Russell and Mary Joseph

Re: Kara Resources Mining Lease MC4322 - Letter of objection and request for further information

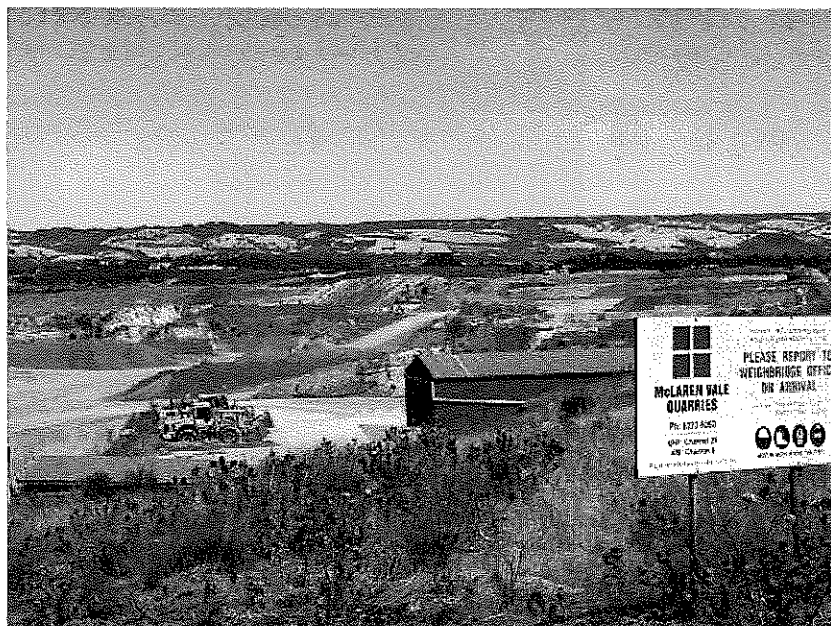
- i. Context: "The prevention of spread or introduction of declared weeds, pests or plant pathogens into the operations area is important to maintain the current level of condition of the land. The weeds likely to exist on the land are those which are generally brought in by stock and machinery....
- ii. Criteria: Survey/Inspection results of site will demonstrate weeds or pathogens at the site are at a level or below surrounding pasture levels
- iii. Control Strategies: Enforcement of good housekeeping to eliminate unnecessary disturbance"
- iv. The risk matrix indicate that it is a minor effect and has a cat 2 rare low likelihood.
- v. The natural process of weeds emerging from the disturbed soil is a certainty when the top soil is placed in bunds similar to the weed and rubbish infested bund on the east side of their mine at McLaren Vale as per following images

- vi. Artichoke thistles are a serious problem in the Nain area as well as Horehound , Sow thistles Marsh mallow, Skeleton weed and Spiny pallenis
 - These seeds can be easily carried by winds to nearby properties.
 - Weed infestation will have a major effect on crop quality and it will cause economic loss and inconvenience for the locals in eradicating them.
- vii. The following photo of the weed infested entrance site at McLaren Vale clearly indicates operations are not conducted in a manner which minimises the spread of weeds and pathogens and unreliable maintenance of the site.

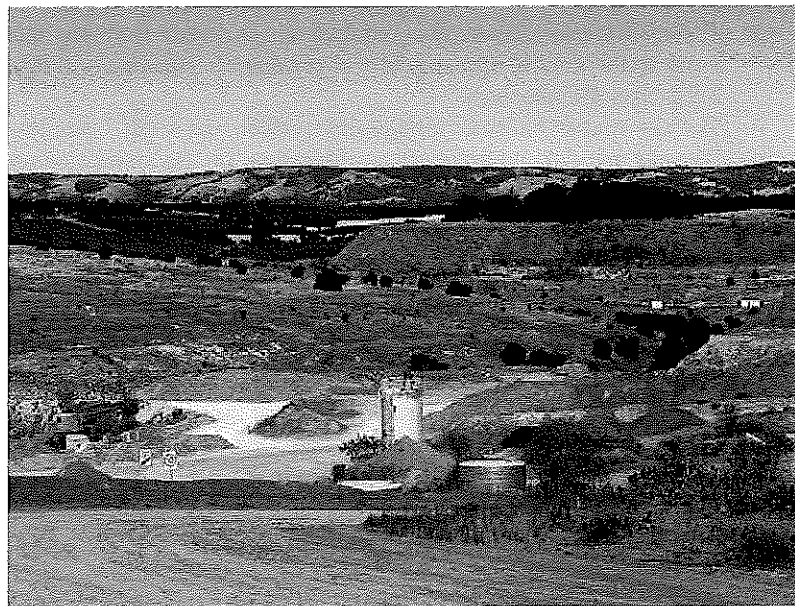
- v. As stated above, our experience is that dust generated in this area from normal farming activity is rare as the no till method for cropping is utilised for adjoining and much of the local farmland as can be seen from the dust laden mine site at McLaren Vale below

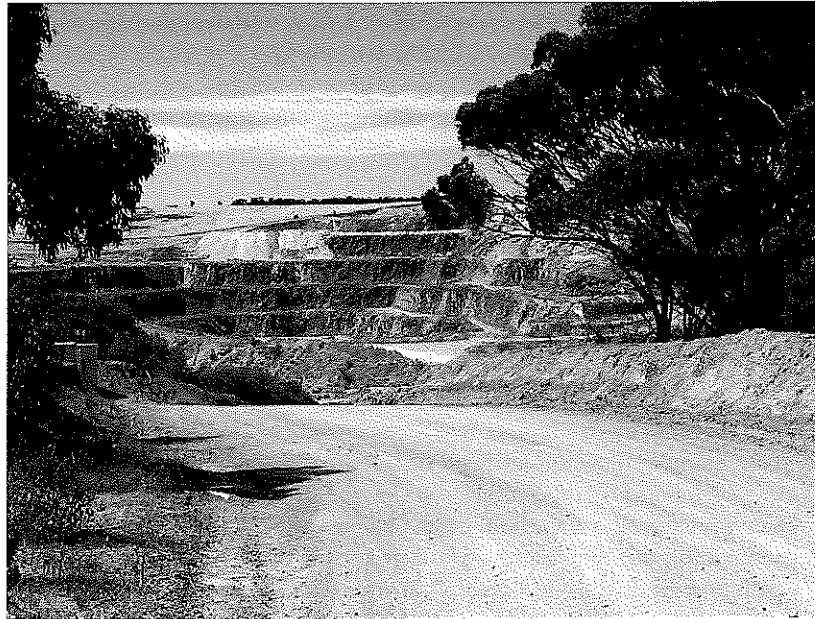
- iii. When mining ceases there will be a large sized crater similar to the above at the McLaren Vale mine site
 - iv. To suggest it is easier to farm the resulting valley than the existing hill is ridiculous
